**Re: Data Adequacy Supplement, Rice Solar Energy Project (09-AFC-10)
Application for Certification**

Supplement

In Response to Data Adequacy Review

Rice Solar Energy Project

FIGURE DA3.0-4
ALTERNATE TRANSMISSION LINE
ROUTE FOR MWD INTERCONNECTION
RICE SOLAR ENERGY PROJECT
RIVERSIDE COUNTY, CALIFORNIA

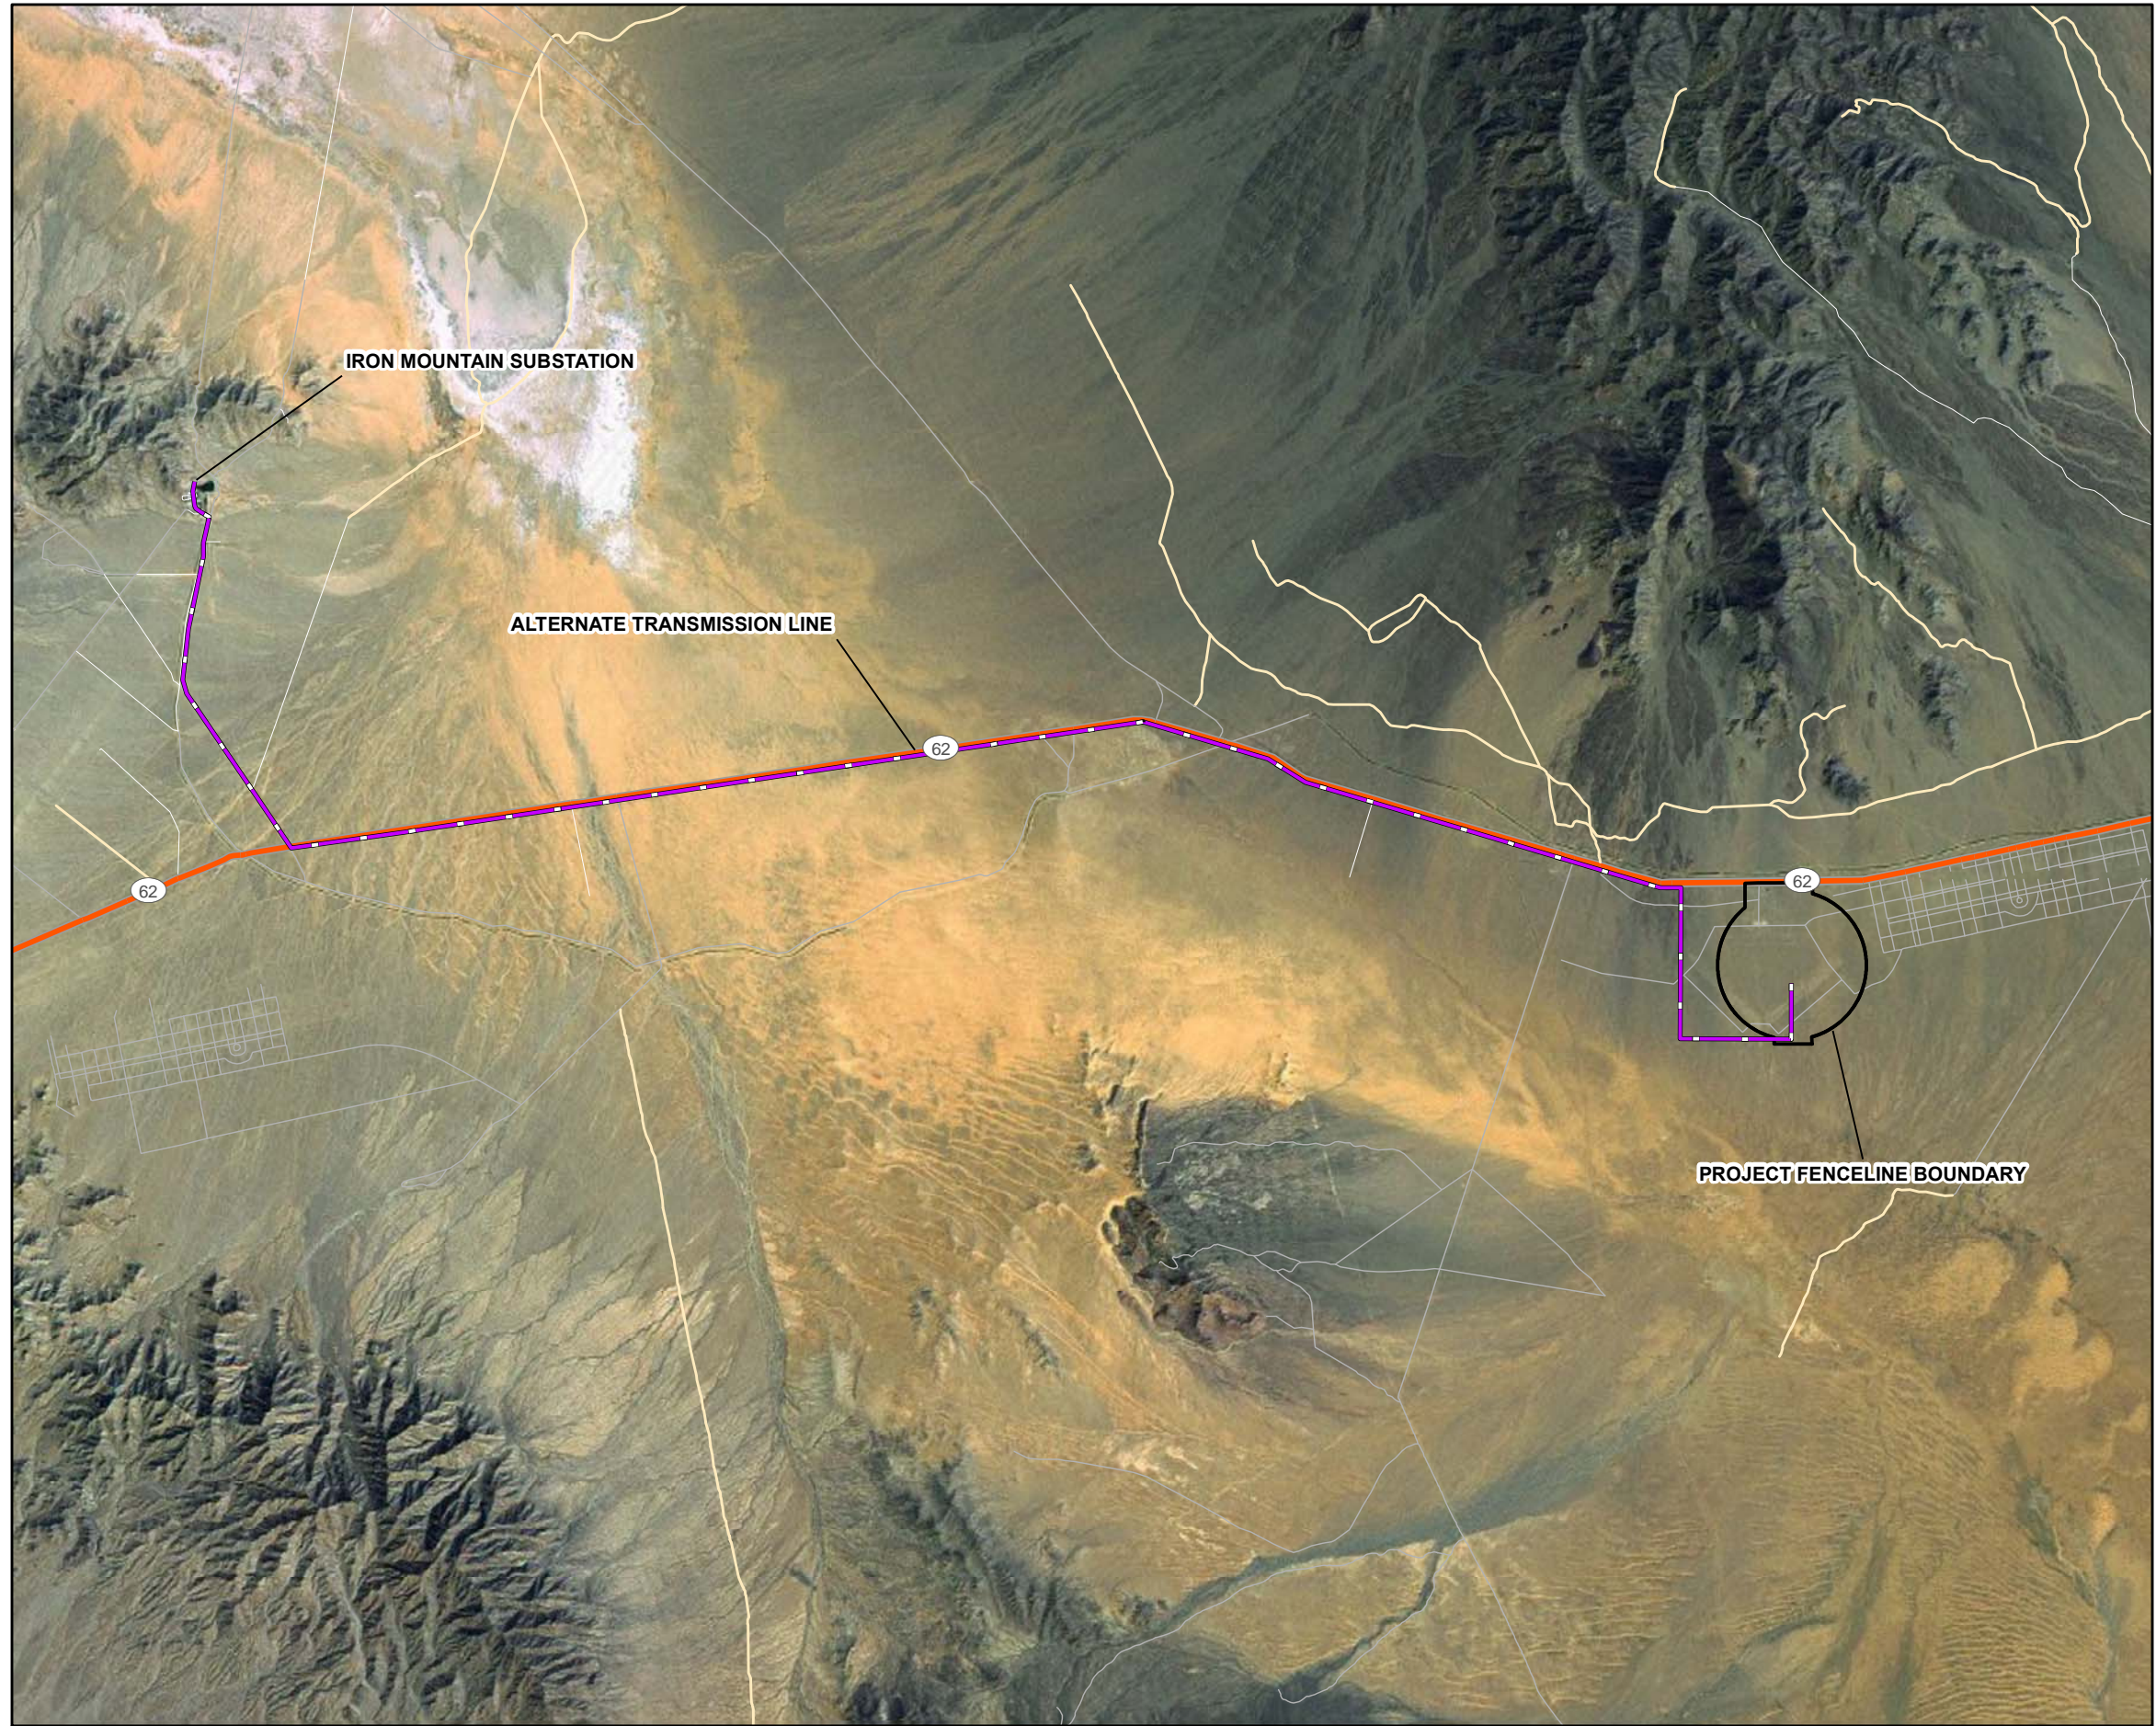
Please submit a drawing showing the alternate route(s) of the proposed 230 kV generator tie lines to the MWD line or others and terminating point of interconnection.

Response: Attachment DA3.0-4 shows the alternative route to the MWD line.
